Traditions II - Block 349 Medium Density

Servicing and Stormwater Management Report

**Reference: 1883 Stittsville Main
Response to First Formal Review Comments (D07-12-24-0142)
Our File No.: 124097**

TRADITIONS II - BLOCK 349		
POST-DEVELOPMENT STORM DRAINAGE AREA PLAN		
SCALE 1 : 750		
DATE JUL 2025	JOB 124097	FIGURE 5.1

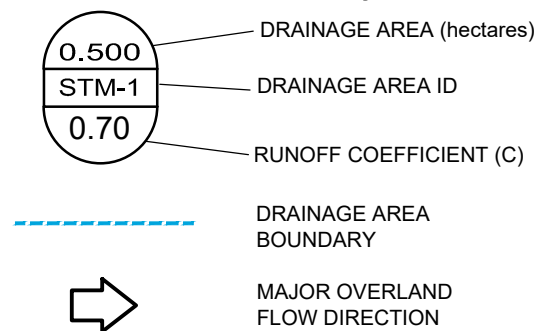
12. Section 4.3.3: The report does not list Area STM-7 Uncontrolled, when compared to Figure 5.1.

17. Appendix C: Table 4, Table 5, Table 6 and Table 7, the runoff coefficients do not match the runoff coefficient listed on the Storm Drainage Plan.

Response: Report revised.

Response: Plan revised.

**FIRE HYDRANT COVERAGE
PLAN**

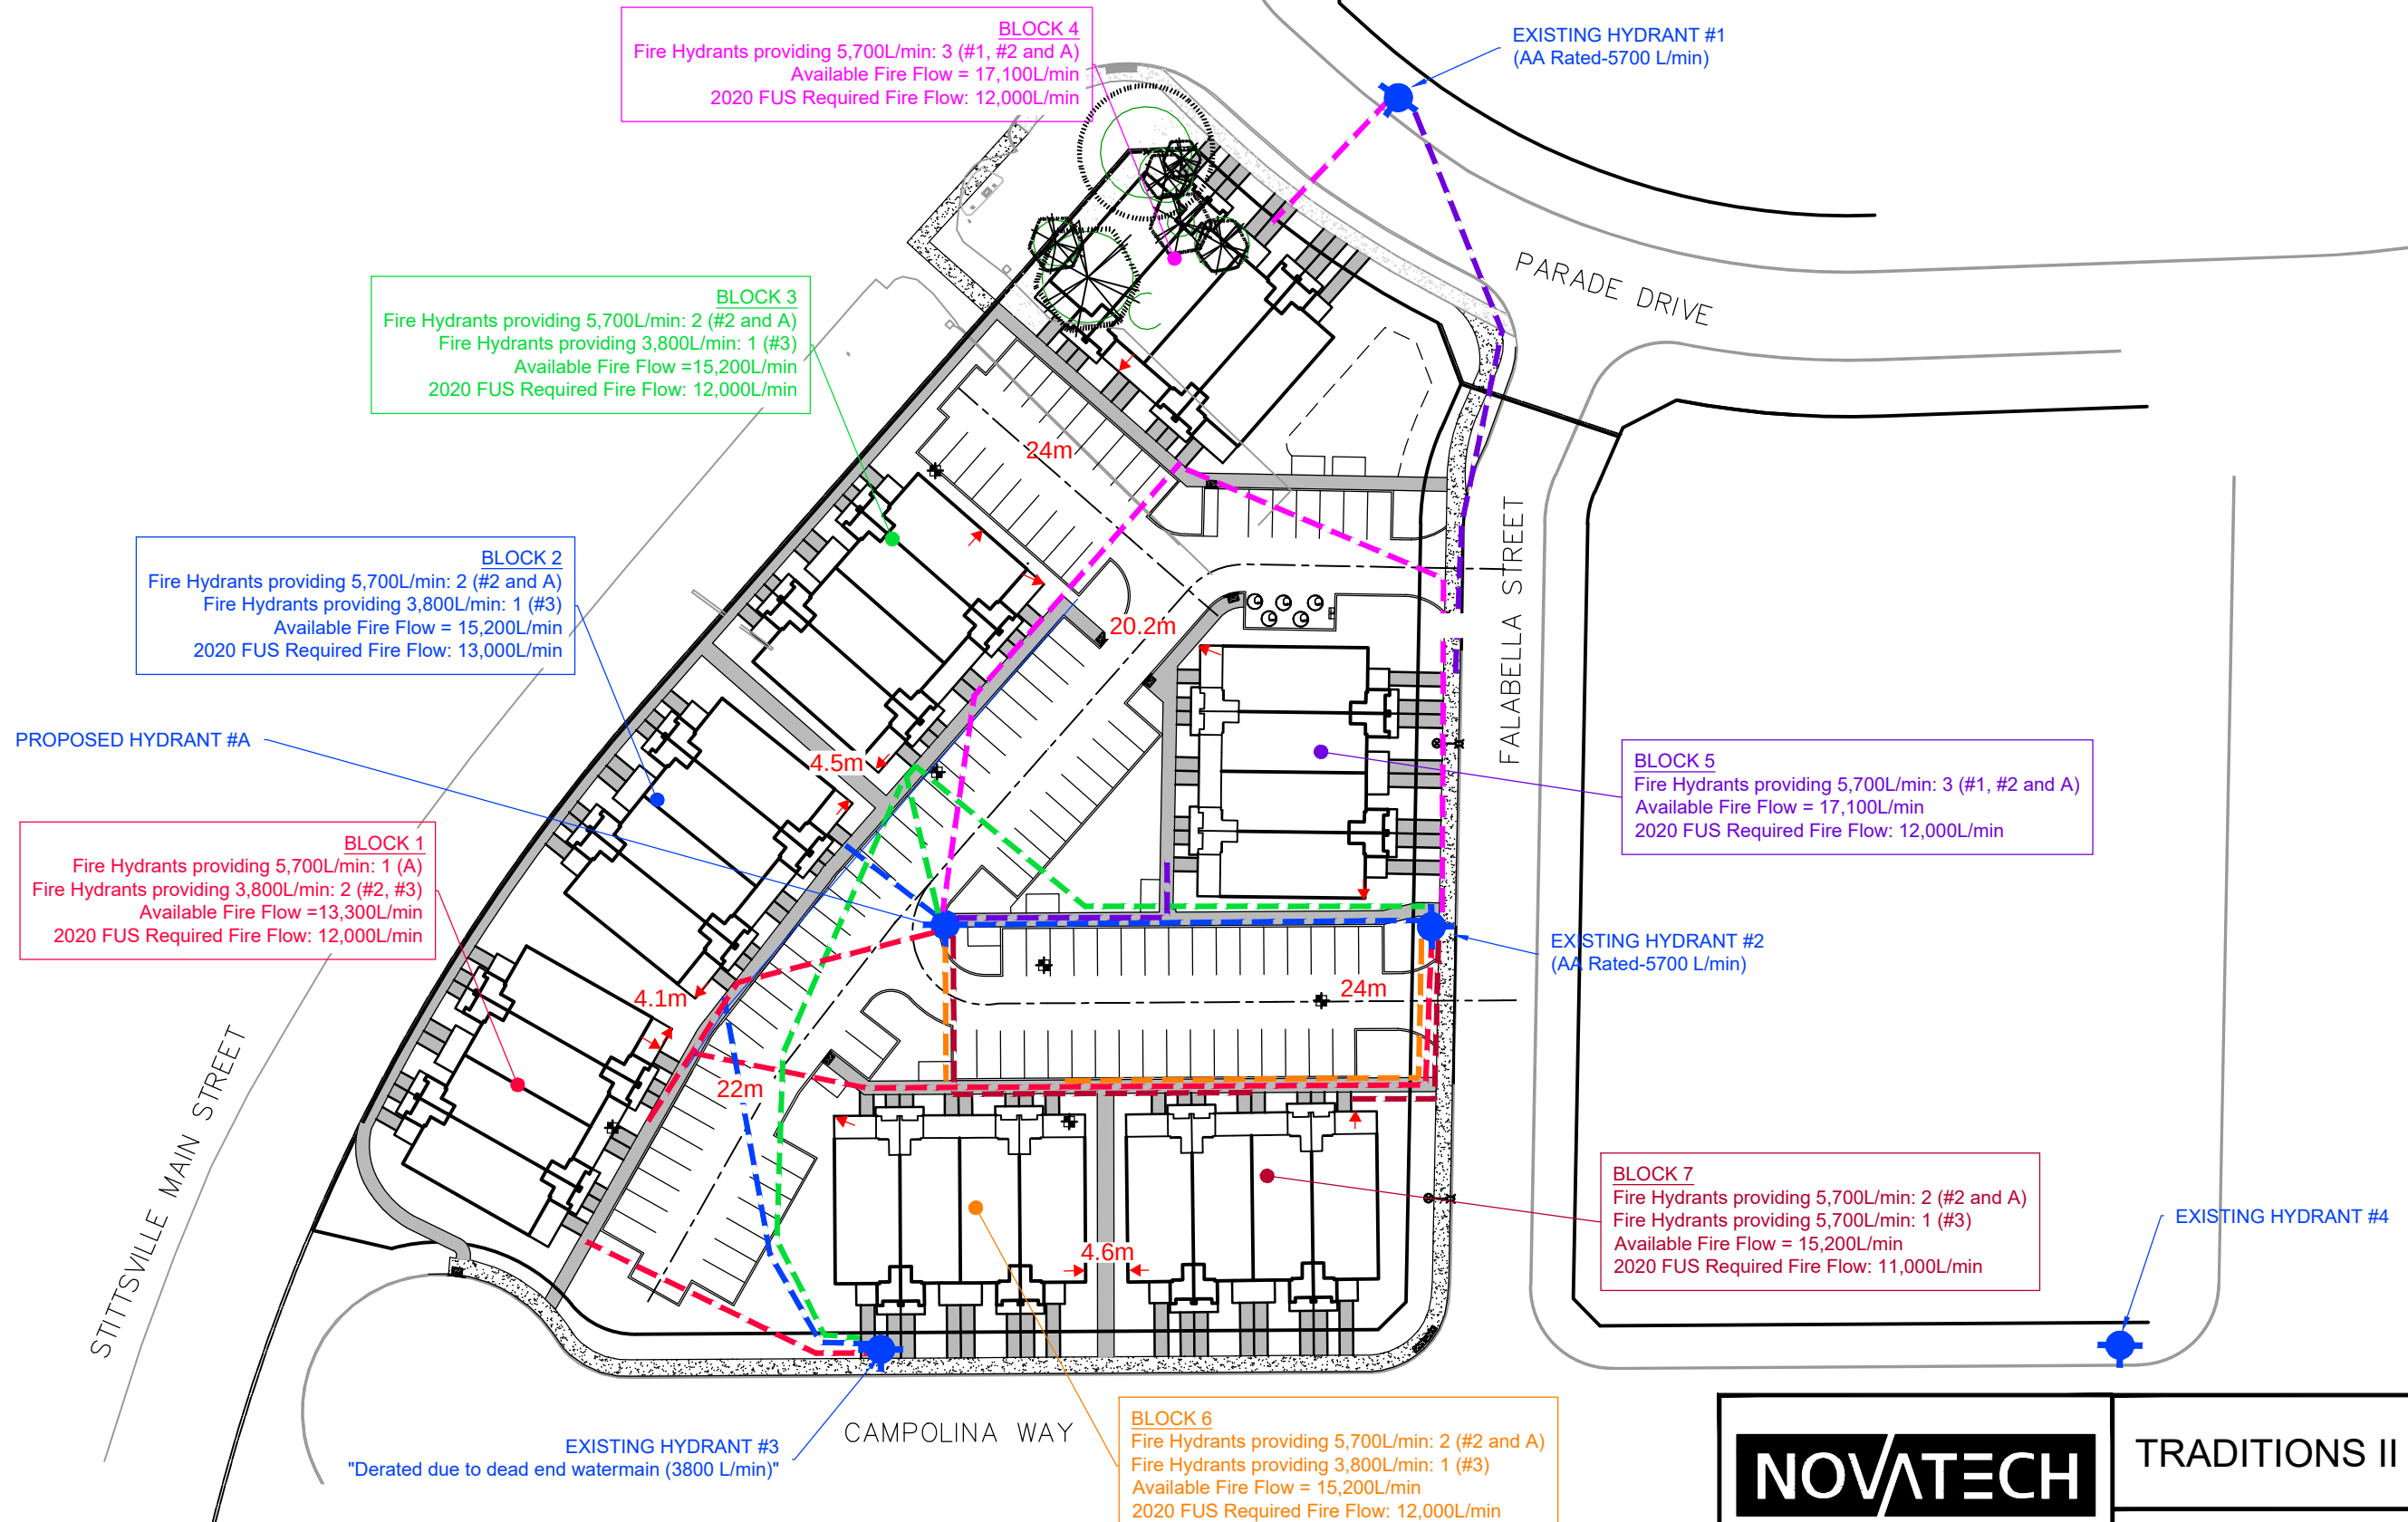
21. Appendix E: Please re-check your exposure distances. Some of the building offsets and Description/Address noted in the Table 6 Worksheets appear to be incorrect. Exposure distance figure for Block 4 and Block 5 is missing.

Response: Exposure distances for all blocks have been added to Figure 7.1

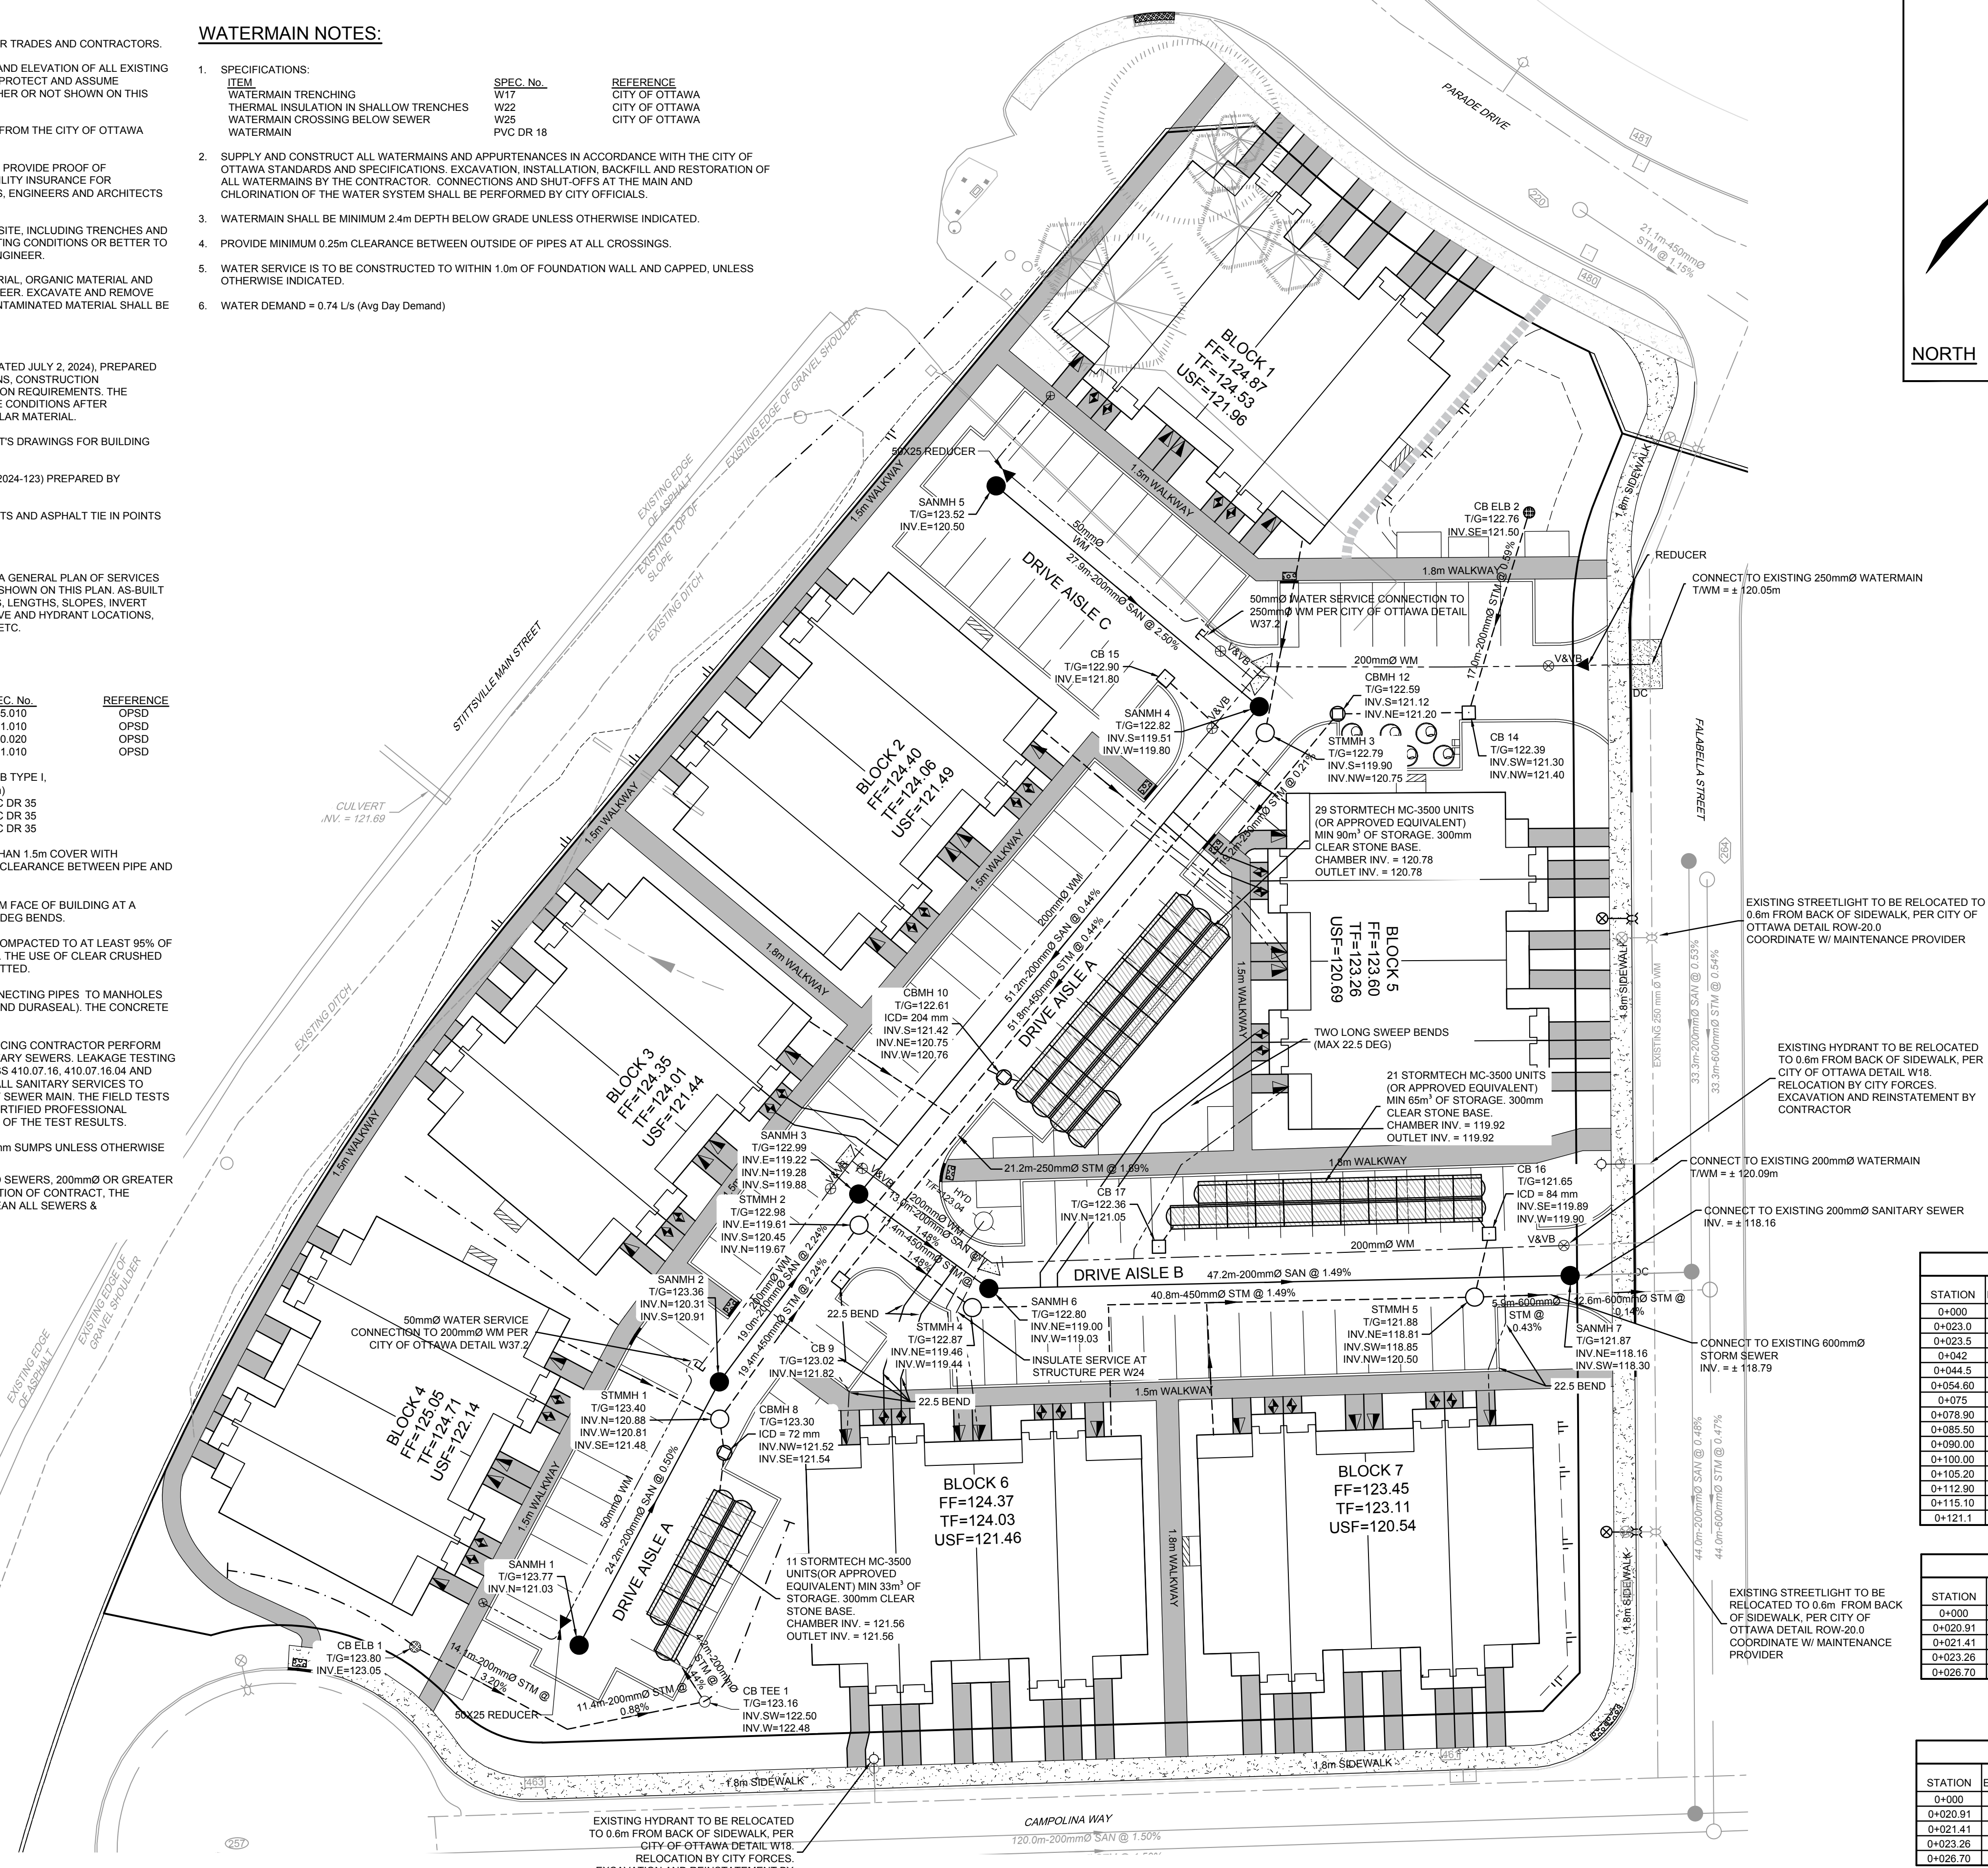
28. Please note the ICD locations and sizes on the plan.

29. The existing watermain stub is 200mm diameter. Please update on the plan.

Response: Plan revised.

Response: Plan revised.
